PSE&G Public Service
Electric and Gas
Company

SAFETY EVALUATION REPORT
OPEN AND CONFIRMATORY ITEM STATUS
HOPE CREEK GENERATING STATION
DOCKET NO. 50-354

SER Confirmatory Item No. 14 (SER Section 6.3.5 and 15.9.3)

Loss-of-Coolant-Accident Analysis

Title: Peak Cladding Temperature and Maximum Local Oxidation

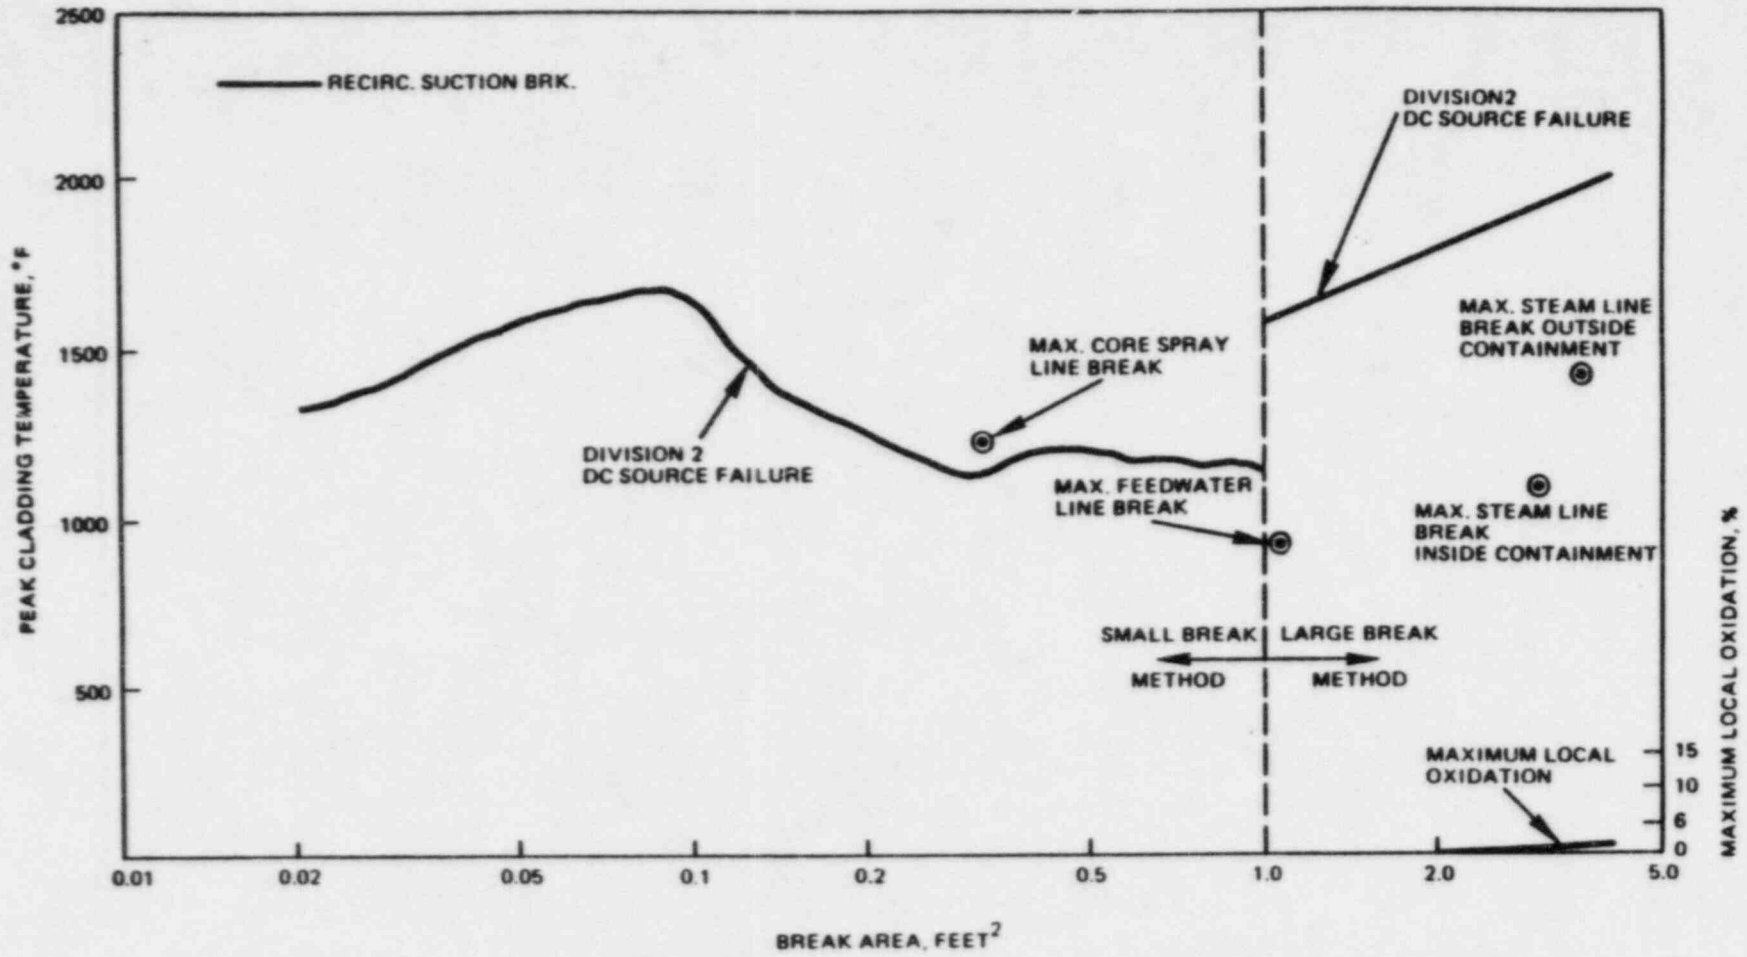
This replaces Figure 6.3-14

Title: Water Level Inside Shroud vs. Time After Break (Small Break Model) (0.4 ft^2 Recirculation Section Break, Failure of Channel A DC Source)

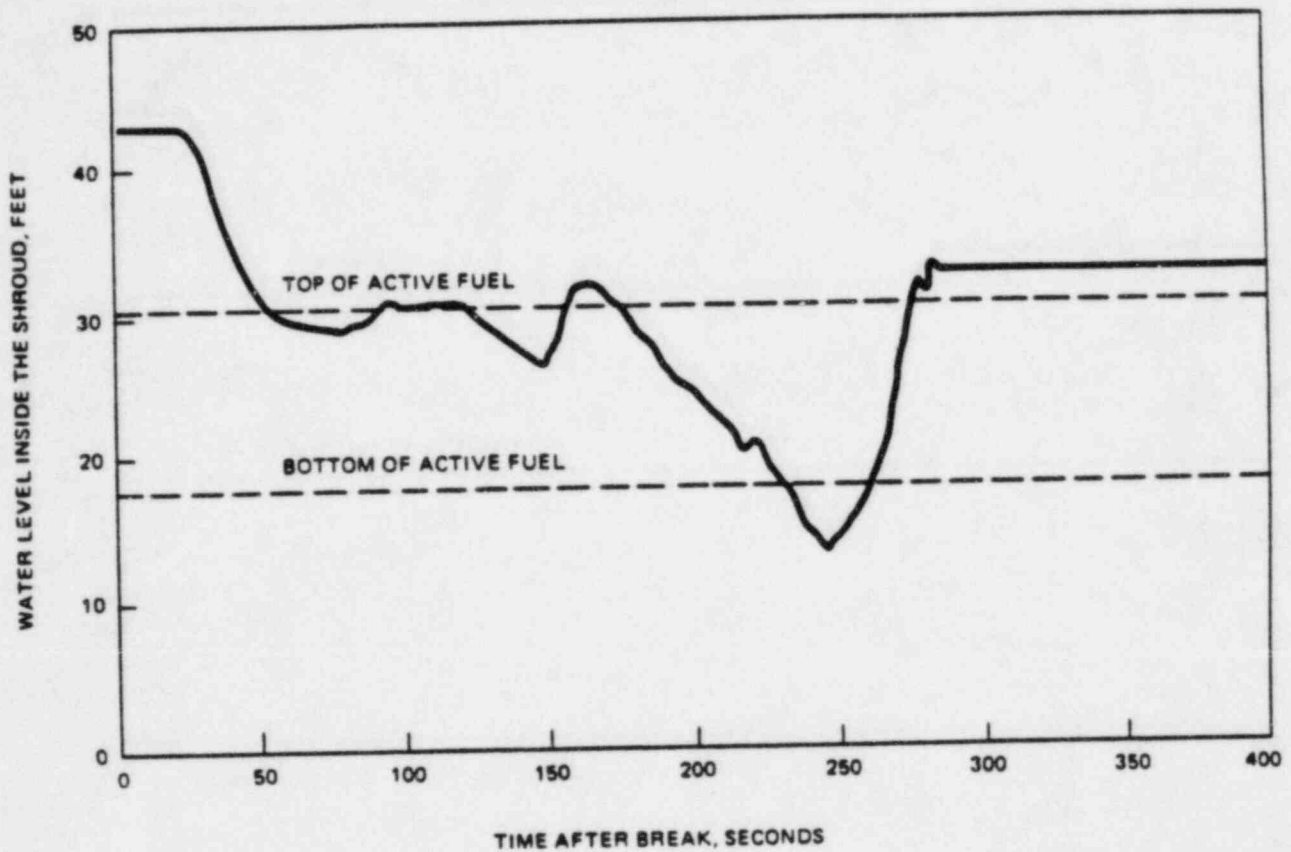
This replaces Figure 6.3-42.

Title: Reactor Vessel Pressure vs Time After Break
(Small Break Model) (0.4 Ft² Recirculation Section
Break, Failure of Channel A DC Source)

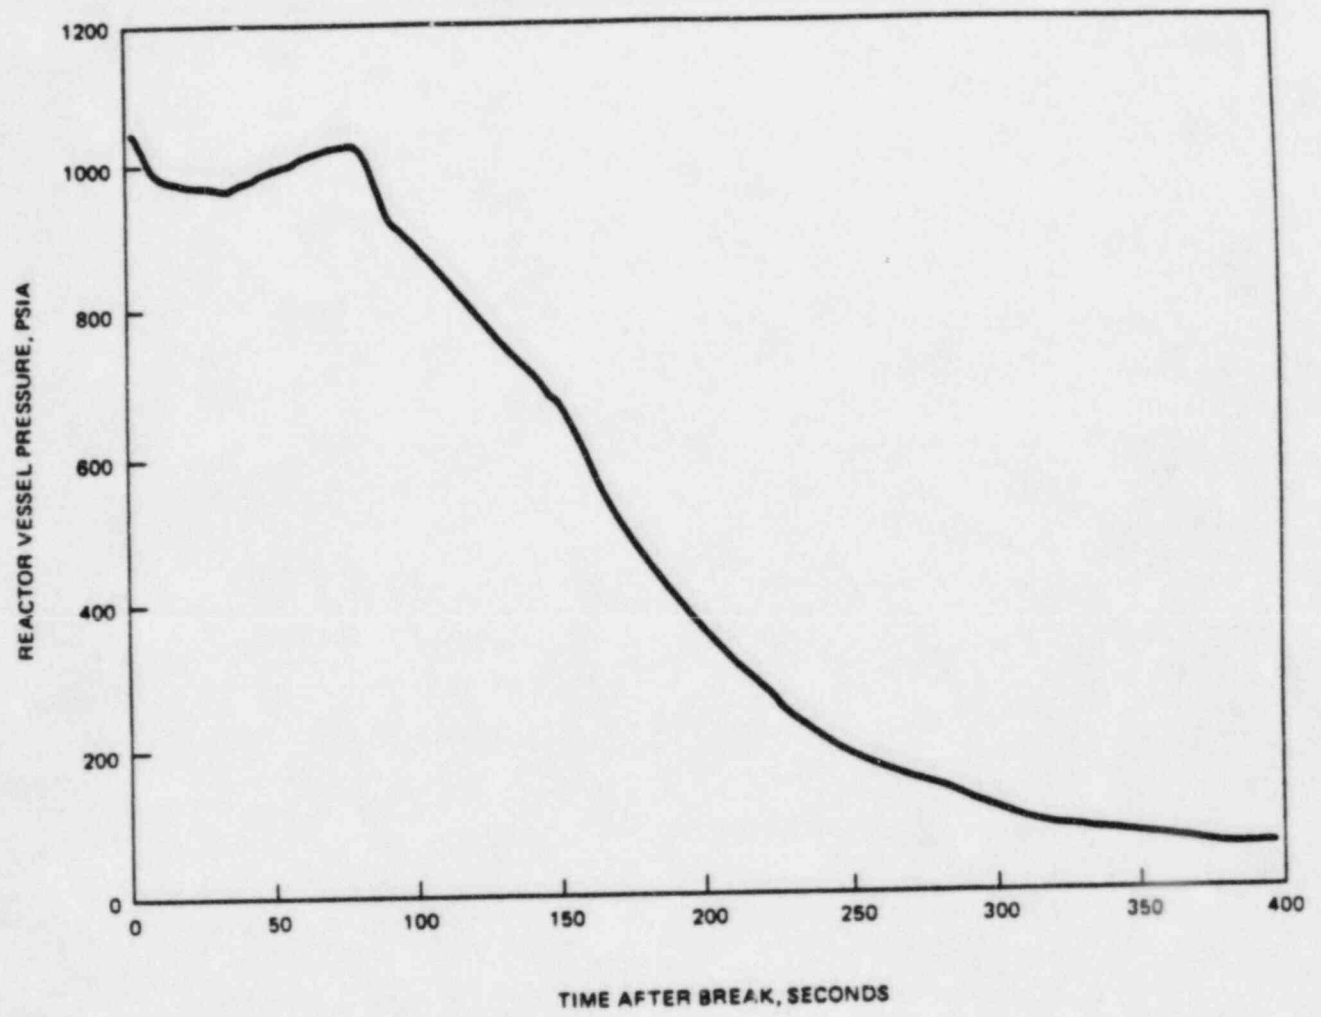
This replaces Figure 6.3-43.

Title: Fuel Rod Convective Heat Transfer
Coefficient vs Time After Break (Small Break Model)
(0.4 ft² Recirculation Suction Break, Failure of
Channel A DC Source)

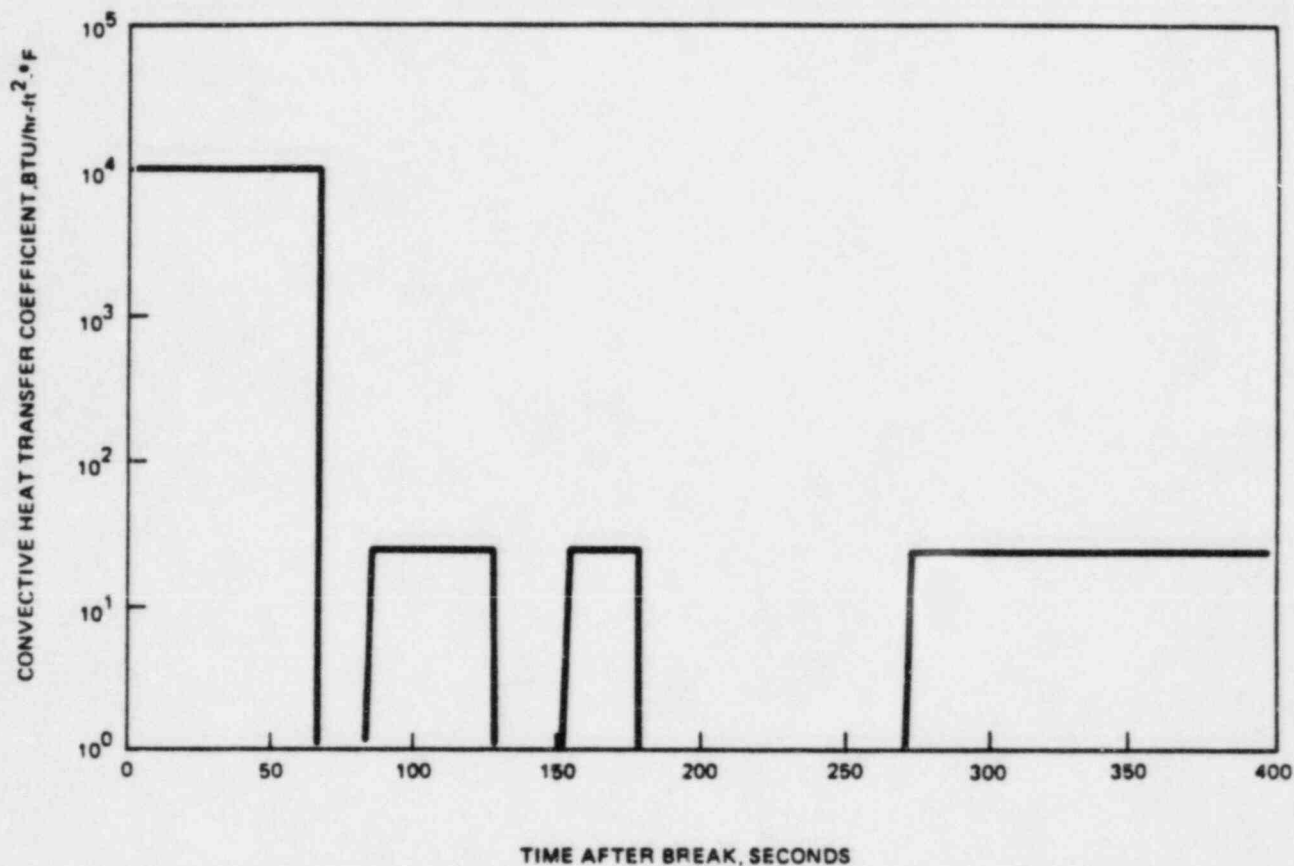
This replaces Figure 6.3-44.

Title: Fuel Rod Convective Heat Transfer Coefficient vs. Time After Break (Maximum Main Steam Line Break Inside Containment, Failure of Channel A DC Source)

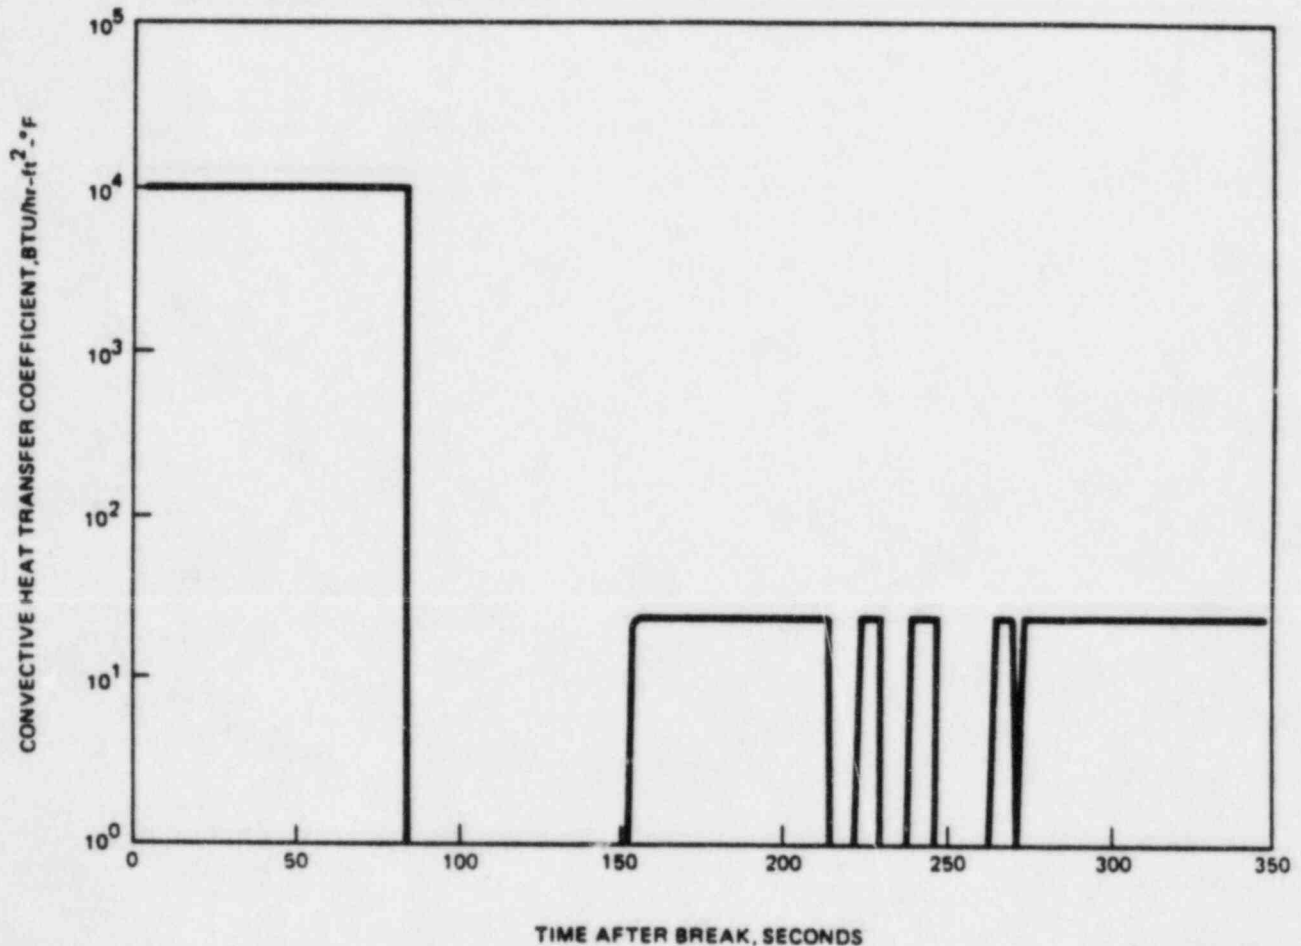
This is to replace Figure 6.3-56.

Title: Water Level Inside Shroud vs Time After Break
(Maximum Main Steam Line Break Outside
Containment, Failure of Channel A DC Source)

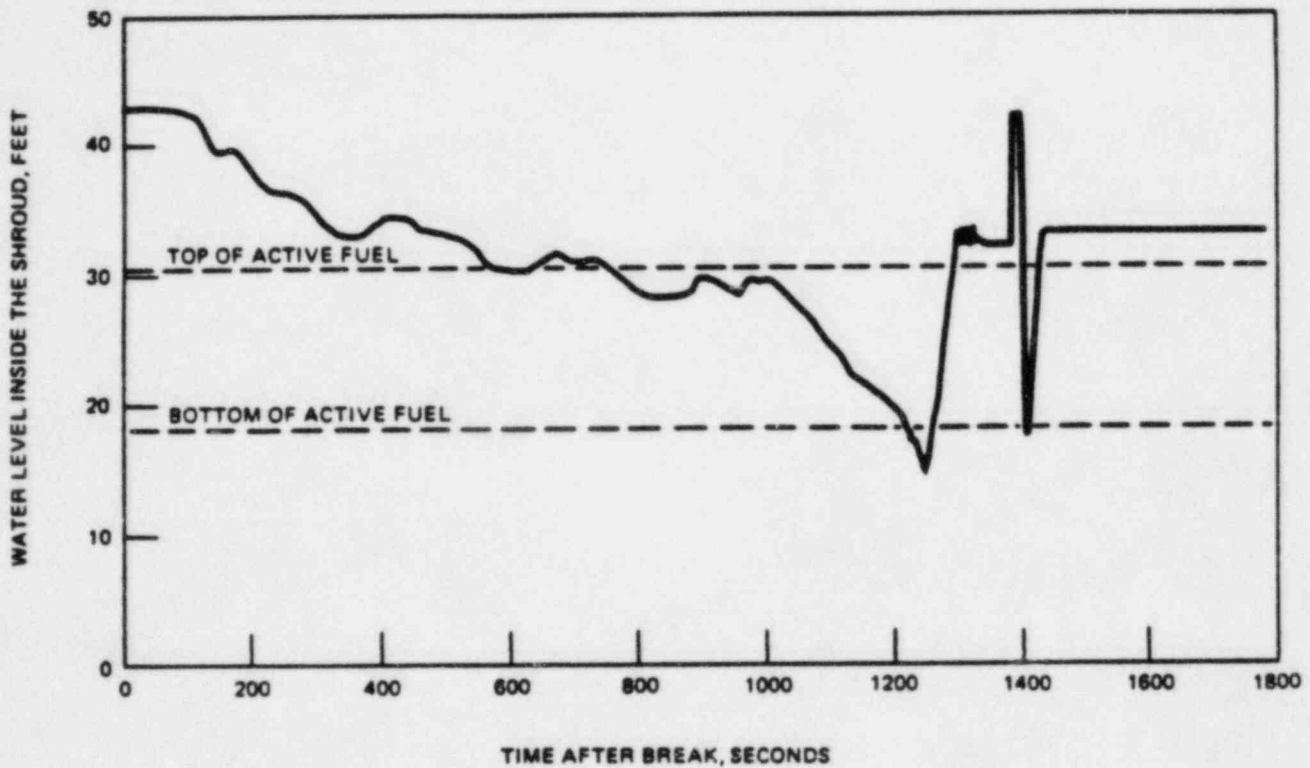
This replaces Figure 6.3-58.

Title: Reactor Vessel Pressure vs Time After Break
 (Main Steam Line Break Outside Containment, Failure of Channel A DC Source)
 (Maximum)

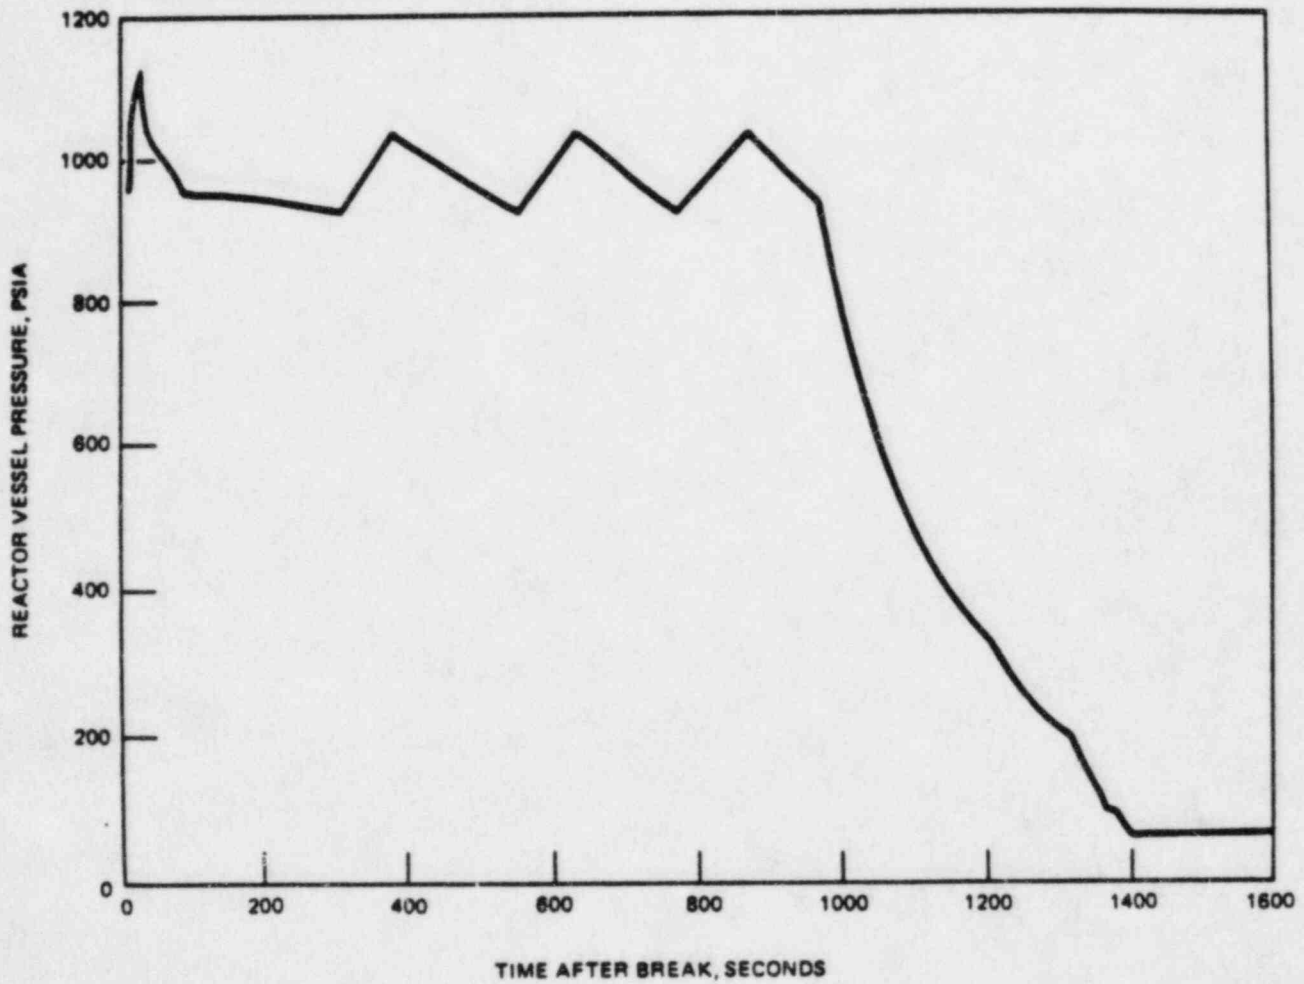
This replaces Figure 6.3-59.
